LaSalle County Station, Units 1 and 2
Facility Operating License Nos. NPF-11 and NPF-18
NRC Docket Nos. 50-373 and 50-374

Subject: Response to Request for Additional Information Related to Technical
Specification 3.8.3, "Diesel Fuel Oil and Starting Air"
(TAC Nos. MD8674 and MD8675)

Attachment: Response to NRC Request for Additional Information

Figure 1: Division 1 and 2 Diesel Generator 7 Day Usable Fuel Oil Requirements

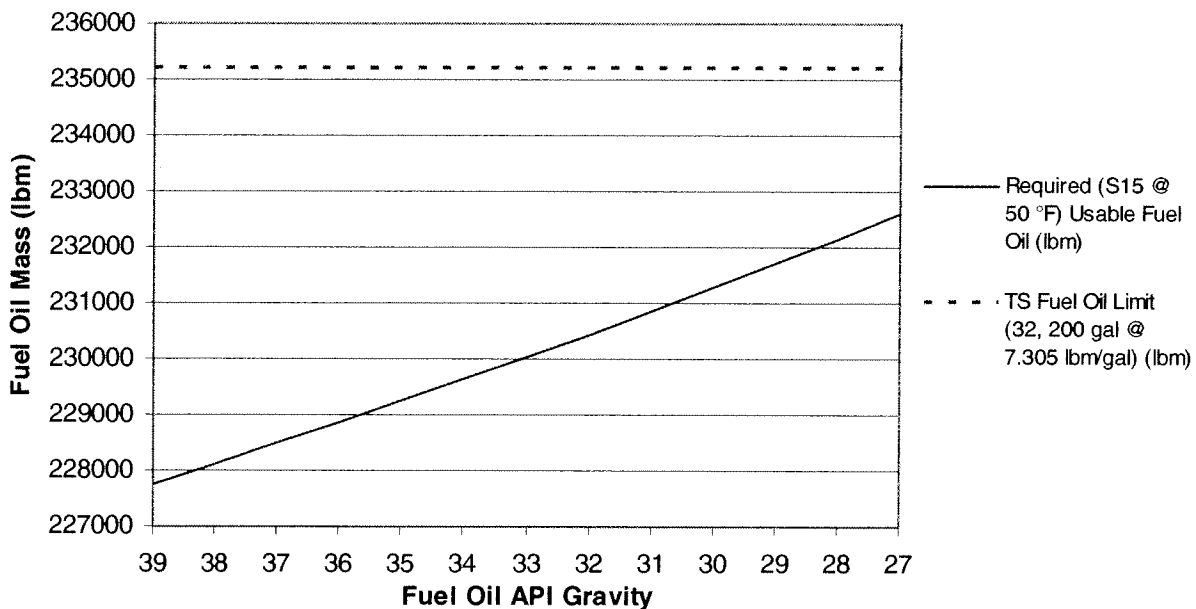
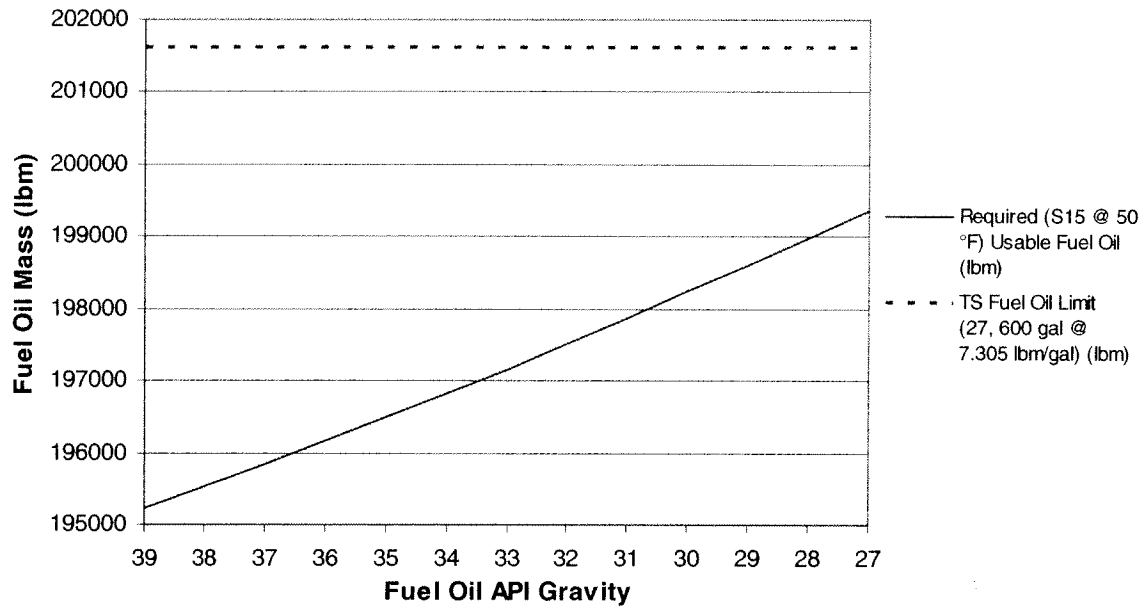
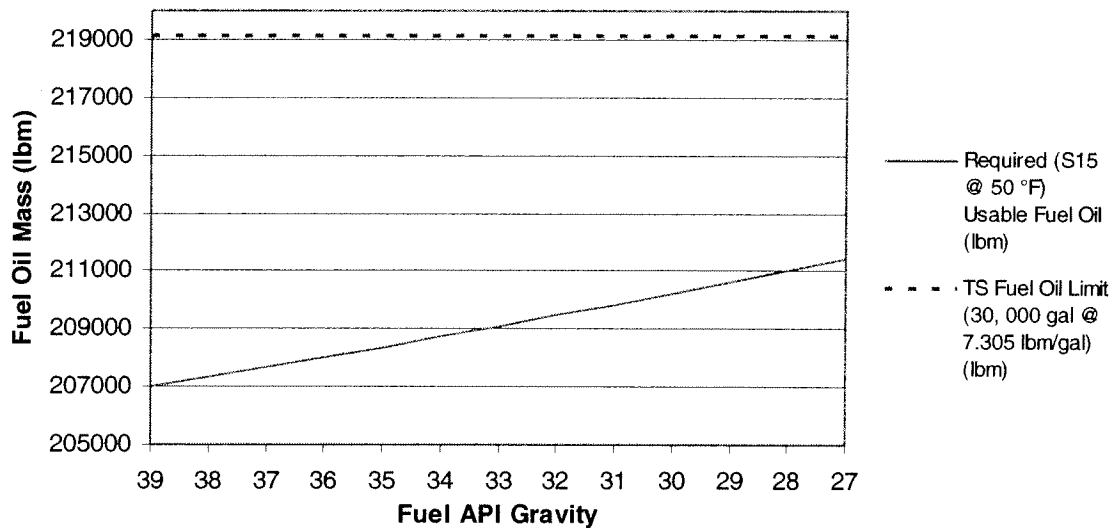
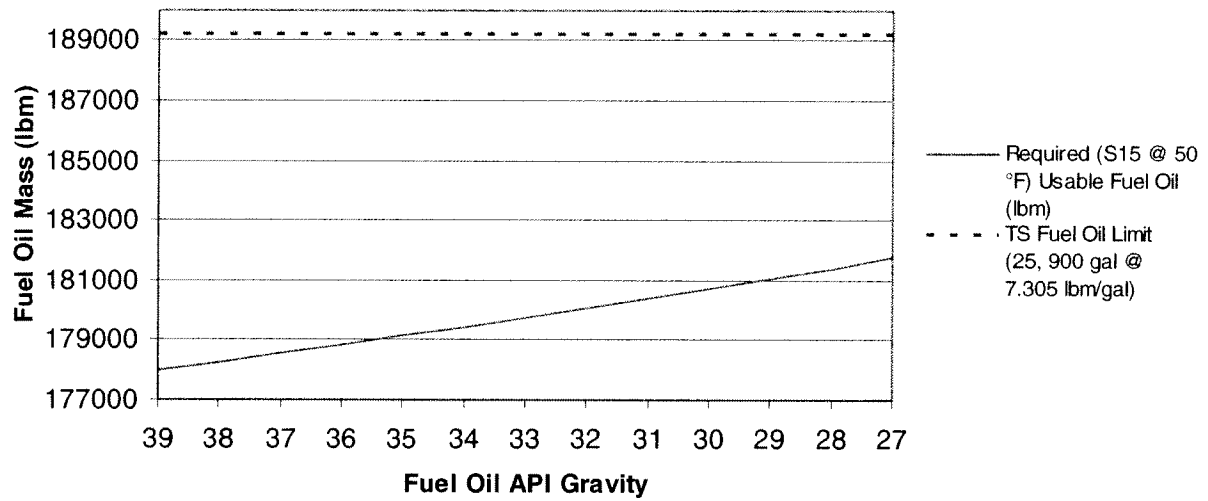
Below Table 1 (Page 3) it is stated that "The proposed numerical volumes requirements are based on calculating the maximum required fuel consumption (lbm) over the American Petroleum Institute (API) gravity range allowed by SR 3.8.3.2 converted to a single volumetric value (gallons) at an API gravity of 30 at a nominal temperature of 60 °F." Some commercially available ULSD is in the API gravity band of 27 to 39. Provide the bases for using an API gravity of 30, and provide justification as to why it is a conservative value.

Exelon Generation Company's, LLC (EGC's) calculation considered all ultra-low sulfur diesel fuel oil (ULSD) across the allowable API gravity band of 27 to 39. This evaluation determined that the maximum mass of fuel would be required when considering the properties of ULSD at an API gravity of 27 at 50 °F. Since measured fuel oil storage tank level is converted to gallons, and fuel is ordered by the gallon, the maximum required mass of fuel was converted to gallons using an API gravity of 30 at 60 °F. Figures 1 through 4 below demonstrate that for the Division 1, 2, and 3 Diesel Generators at LaSalle County Station (LSCS), there is a significant conservative margin between the Technical Specifications (TS) limits of usable fuel oil proposed in TS Bases Table B3.8.3-1, and the actual amount of usable fuel oil required to meet the associated diesel generator's safety function. Furthermore, Figures 1 through 4 show that the proposed TS limits are conservative across the entire band of API gravities allowed by the LSCS Diesel Fuel Oil Testing Program.

Figure 5: Typical Diesel Fuel Gross Heating Value Compared ULSD (S15) Heating Value

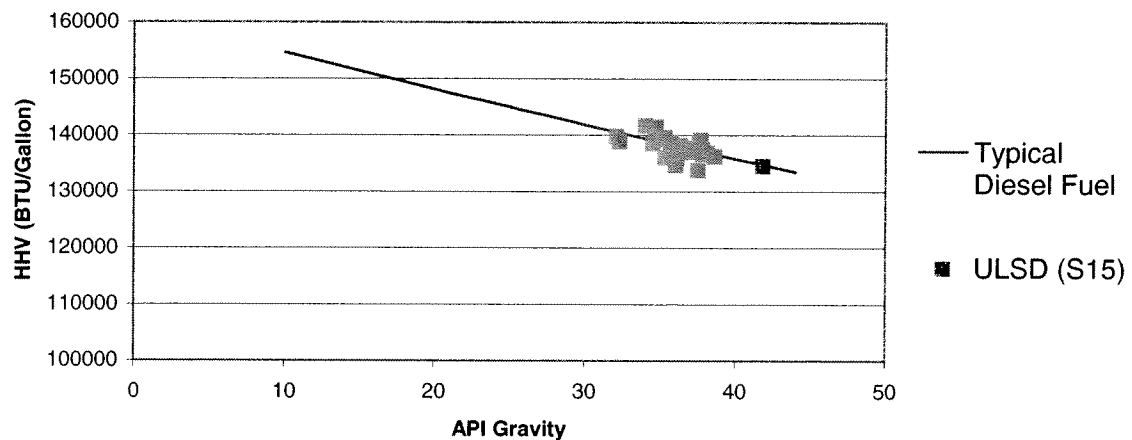
In Section 3.0 (page 4 of 11) it is stated that "EGC in its evaluations used a 1% reduction in energy content for ULSD compared to the diesel fuel that was used as the basis in the design of LSCS." Provide the bases for the 1% reduction value, and provide justification as to why it is a conservative value.

The heat content of the samples in Table 2 was compared to typical heat content values of legacy fuels found in Table 1. This comparison is shown graphically in Figure 5 below.

The collected S15 gross heat content data shows some variations for the similar API gravity. The data scatter in Figure 5 is likely due to differences in base oil stock and refining processes among fuel oil refineries, as well as testing accuracies. The tests were performed in accordance with either ASTM D-4809 or ASTM D-240. The Table 2 data shows that the gross heat content results for all the samples as a function of API gravity is consistent with the predictions of ASTM D-4868 and NBS Publication 97 data shown in Table 1. This analysis supports the claim that the heat content of S15 fuel is only marginally different than that of the older fuels with higher sulfur content.

Moreover, literature from Exxon Mobile Corporation and BP, the preferred suppliers for the fuel oil delivered to LSCS, report that S15 fuel is expected to have approximately a 1% reduction in fuel economy caused when compared to higher sulfur content (S500) fuel. Corporate publications from Marathon Oil Corporation and Chevron Corporation confirm that a 1% reduction in fuel economy is typical (this information is available on the respective company websites). Figure 5 demonstrates that the results of analyses performed by EGC are consistent with these claims.
